Access Compliance Report

Public Rights-of-Way

Intersection ID: 43474	Main Street: LIONESS_ST	Cross Street: LIONS_MANE_ST	Location: SW
ADA ID: E861CF02B7E9	Ramp Type: PerpDiag	Initial Pass/Fail: Fail	Overall Compliance: No
Severity Score: 8.75			
Codes/Mitigation Info/Possible Solution		Field Measurements/Component Compliance

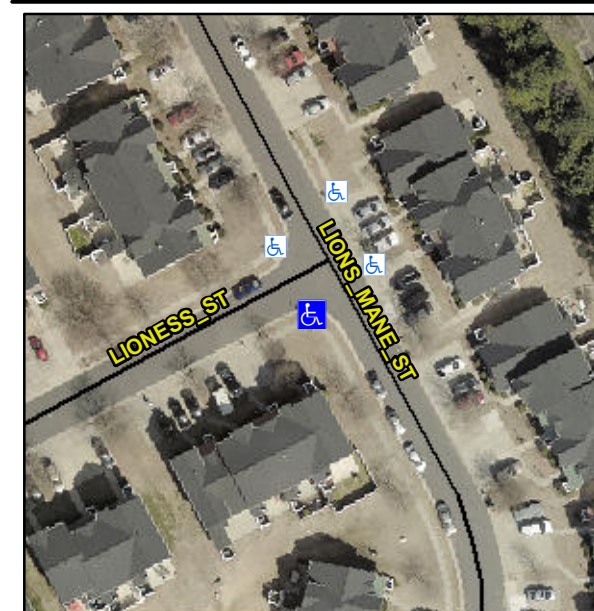
Not Found, R304.5.1

Compliance	Description	Data	Compliance	Description	Data
N/A	Ramp Length (in)	48.0	Yes	Ramp Slope (%)	7.8
No	Ramp Width (in)	40.0	Yes	Ramp XSlope (%)	1.5
N/A	Flare Type LT	N/A	N/A	Flare Type RT	N/A
N/A	Flare Slope LT (%)	N/A	N/A	Flare Slope RT (%)	N/A
N/A	Flare Traversable LT?	N/A	N/A	Flare Traversable RT?	N/A
N/A	Landing Length (in)	N/A	N/A	DWS Provided?	N/A
N/A	Landing Width (in)	N/A	N/A	DWS Contrast?	N/A
N/A	Landing Slope (%)	N/A	N/A	DWS Length (in)	N/A
N/A	Landing X Slope (%)	N/A	N/A	DWS Full Width?	N/A
N/A	Landing Curb? (Y/N)	N/A	N/A	DWS Offset (in)	N/A
N/A	Shared Landing?	N/A			
N/A	Gutter Ponding?	N/A	N/A	Gutter Slope (%)	N/A
N/A	Gutter Lip Ht (in)	N/A	N/A	Gutter X Slope (%)	N/A
N/A	Painted X Walk1?	No	N/A	Painted X Walk2?	No
	X Walk 1 Direction	To E		X Walk 2 Direction	To N
N/A	X Walk 1 Width (in)	N/A	N/A	X Walk 2 Width (in)	N/A
	X Walk 1 Slope (%)	4.4		X Walk 2 Slope (%)	2.8
	X Walk 1 X Slope (%)	0.6		X Walk 2 X Slope (%)	2.2

Remove & Replace Curb Ramp With Two New Directional Ramps or Equivalent.
